Subject: UniStar Nuclear Energy, NRC Docket No. 52-016
Response to Request for Additional Information for the
Calvert Cliffs Nuclear Power Plant, Unit 3,
RAI 327, Probable Maximum Surge and Seiche Flooding

**Response to NRC Request for Additional Information
RAI No. 327, Question 02.04.05-08, Probable Maximum Surge and Seiche Flooding
Calvert Cliffs Nuclear Power Plant, Unit 3**

Question 02.04.05-08

Figure 1: Comparison of Surge Levels WTON9 (Scenario C) and Scenario B

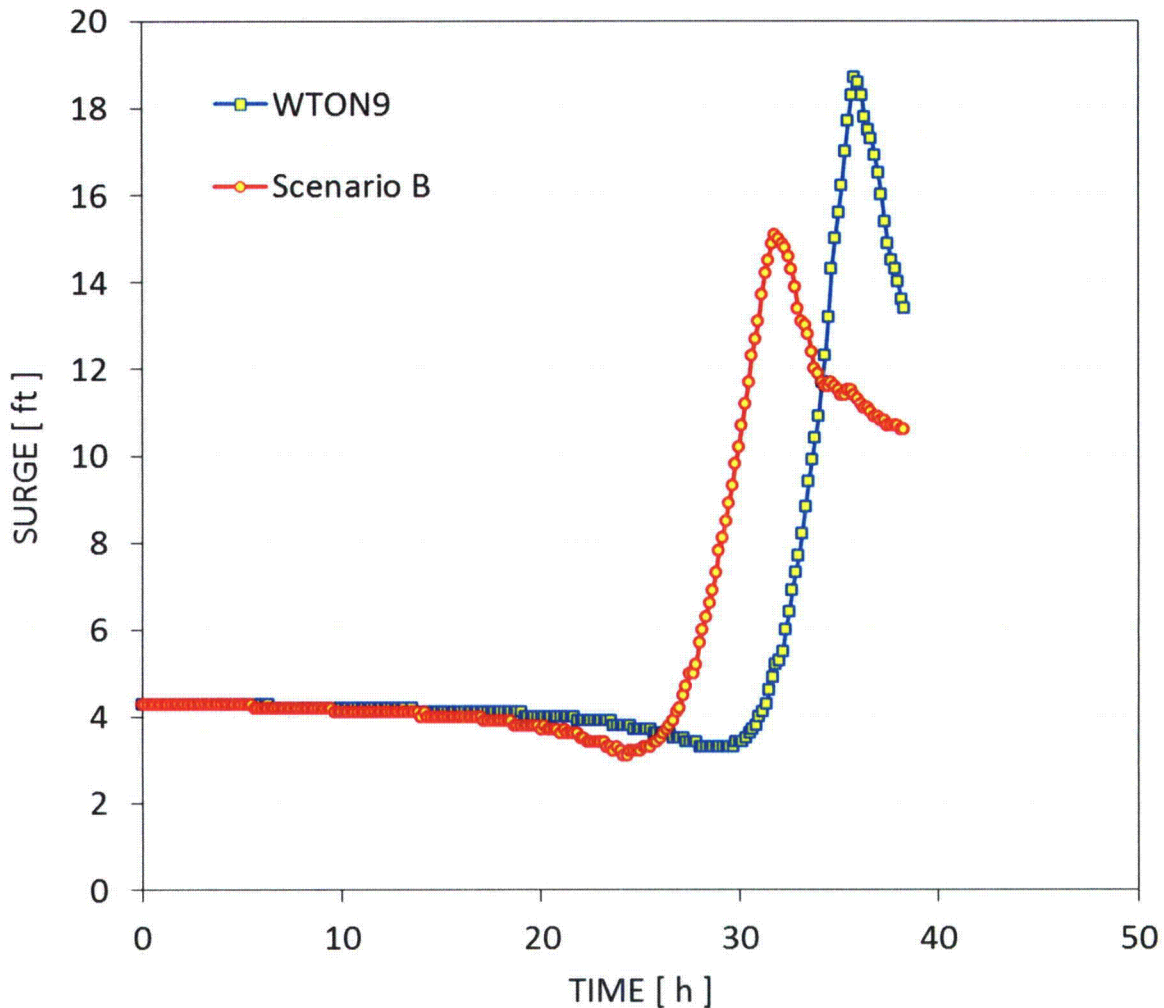
The applicant is requested to explain why the higher stillwater elevation of 18.8 ft, obtained from SLOSH case WTON9, was apparently not used in COLA Revision 7, or provide updated estimates of maximum PMSS water surface elevation accounting for wind wave activity.

Figure 1 shows the surge level computed by RIZZO (labeled Scenario B) and Scenario C (labeled as WTON9) at the same location on land where the maximum surge levels occur. Figure 1 shows that the values presented in Scenario B are lower than the values of the WTON9 (Scenario C) model. This is because, at the 24th hour from the beginning of the simulation, the hurricane makes landfall and the RIZZO analysis incorporates decay values to the pressure gradient and RMW, which in turn diminish the surge value. However, the WTON9 analysis uses a simplistic approach with an equal pressure gradient on both land and water. This simplified approach explains the higher surge value.

In Figure 1, Scenario B is compared to Scenario C because both analyses incorporated the antecedent water level in the SLOSH simulations. Scenario A adds the antecedent water level after the SLOSH simulations, which results in a higher, more conservative result than Scenario B. Scenario A was used as the basis for Calvert Cliffs Nuclear Power Plant (CCNPP) Unit 3 Combined License Application (COLA) Revision 7 FSAR Figure 2.4-23.

In comparing the storm files (.stm) it was observed that the pressure difference in the input file starts at 123 millibar, then is reduced in accordance with reference guidance once the hurricane makes landfall. In the WTON9 (Scenario C) input file, the pressure difference remains constant (123 millibar). The RIZZO calculation assumed decay in the central pressure once the hurricane is over land. The pressure gradient is reduced by a factor varying with time.

The track file for the WTON9 (Scenario C) shows a constant pressure gradient whereas the RIZZO input file has a decreasing pressure gradient after the hurricane makes landfall. The RMW was also assumed to change with respect to pressure gradient, as defined by the relationship between RMW and difference in pressure.

Thus, the change in pressure gradient and RMW values resulted in the difference between the WTON9 (Scenario C) estimated surge value and the reported surge value of 17.6 ft. Although the WTON9 (Scenario C) value of 18.8 ft may be more conservative, it does not reflect a realistic scenario where the hurricane wind speed and pressure gradient is not the same over
